ADDENDUM #1**BL013-26****Purchase and Installation of Blowers at Shoal Creek Filter Plant**

The following addition/changes modify the Bid No. BL013-26 "Purchase and Installation of Blowers at Shoal Creek Filter Plant" Contract Documents, dated November 2025, as first advertised on November 05, 2025.

Photo 1 of 2: (Existing Blowers- Nameplate) Typical of 2

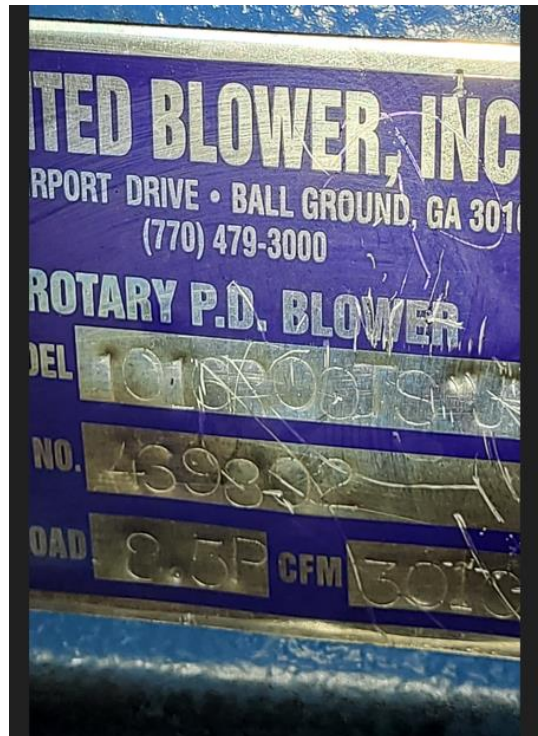
Q3. If suppliers are to be replacing existing Roots 1016 RAS-J blowers, please provide a picture of the nameplate to quote an exact duplicate.

A3. Please see existing blower nameplate photos below.

Model: 1016 Roots J
Ser. No.: 439802
Load: 8.5 PSI
CFM: 3010
See Spec. 11276-B for
additional information about
the existing Blower Model in
operation currently

Photo 1 of 1: (Existing Motors -Nameplate) Typical of 2

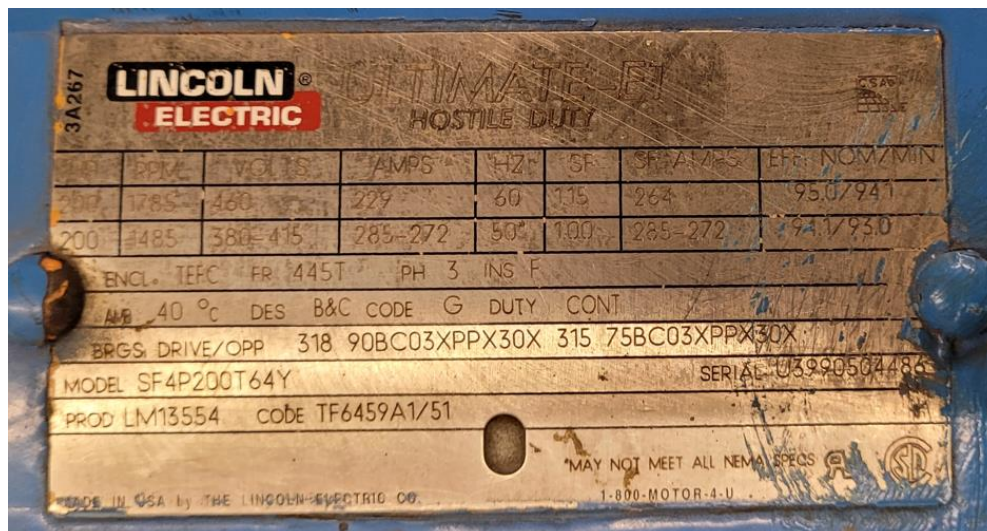
- Q4. If suppliers are to be quoting replacement motors, please provide a nameplate picture to try to duplicate a suitable replacement.**
- A4.** New motors to be matched to the blower provided in this procurment package. Please see existignt blower nameplate photo below..
